**LAND DEVELOPMENT REGULATION ADVISORY BOARD (LDRAB)
LAND DEVELOPMENT REGULATION COMMISSION (LDRC)**

**WEDNESDAY, MAY 27, 2015 AGENDA
2300 NORTH JOG ROAD
KEN ROGERS HEARING ROOM - 1ST FLOOR (VC-1W-47)
2:00 P.M.**

PLANNED UNIT DEVELOPMENT (PUD) ELECTRONIC MESSAGE SIGNS SUMMARY OF AMENDMENTS (Updated 5-21-15)

Figure 8.G.3.B – Typical Example of Time and Temperature Electronic Sign

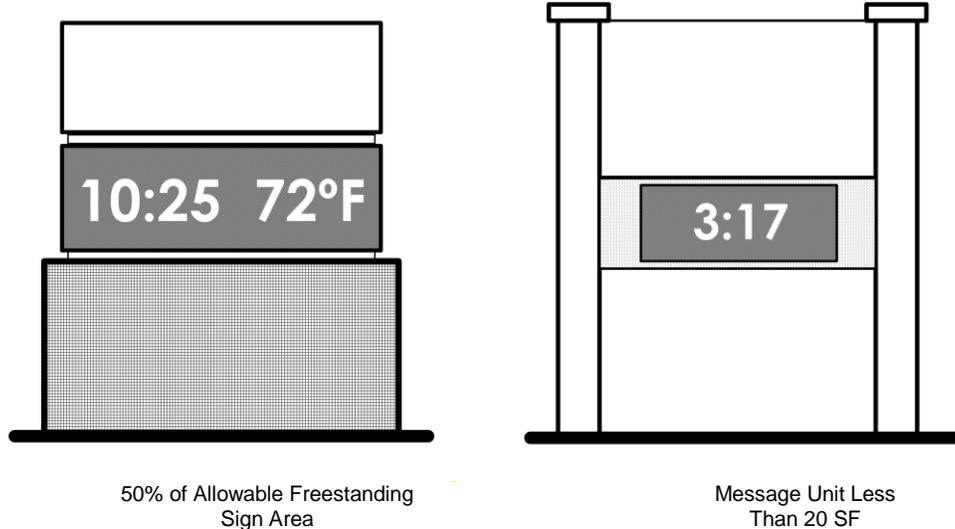
3. Clarify size limits for time and temperature signs to be consistent with existing limits stated in Figure 8.G.3.B – Typical Example of Time and Temperature Electronic Sign.

Signs that only display time or temperature ~~may be approved subject to issuance of a building permit, and~~ where the message unit is 50 percent of the sign face area, not to exceed more ~~less~~ than 20 square feet in sign face area, ~~whichever is less~~; [Ord. 2014-025] [Partially relocated to new Table 8.G.3.B, Electronic Message Sign Types and Approval Process.]

Figure 7.G.2.C - Divider Median Requirements

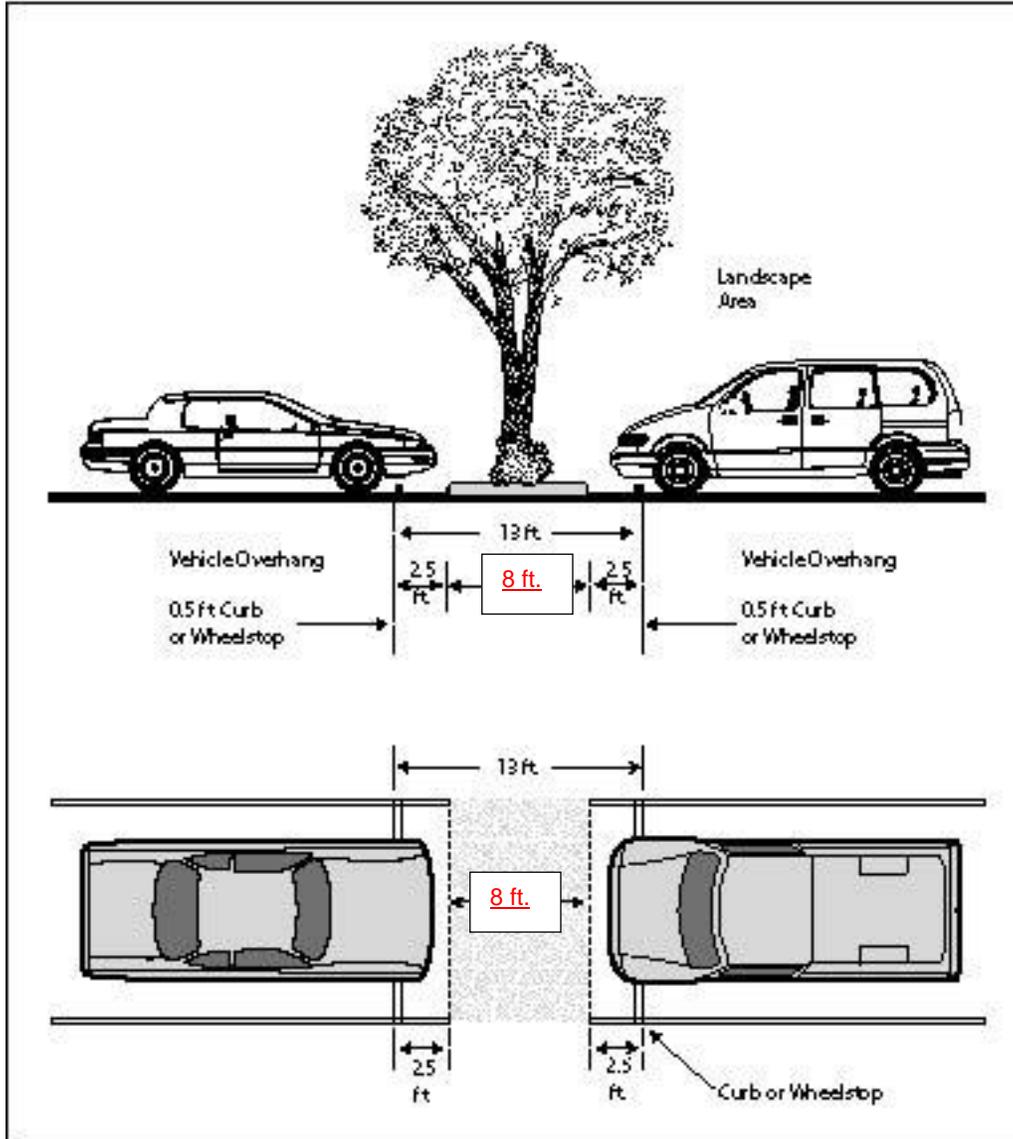
1
2 Part 11. ULDC Figure 7.G.2.C-Divider Median Requirements, (page 44 of 50), is hereby amended
3 as follows:
4

5 **Reason for amendments:** Correct scrivener's error for consistency with eight foot divider median requirement stated in Art. 7.G.2.C, Divider Median.
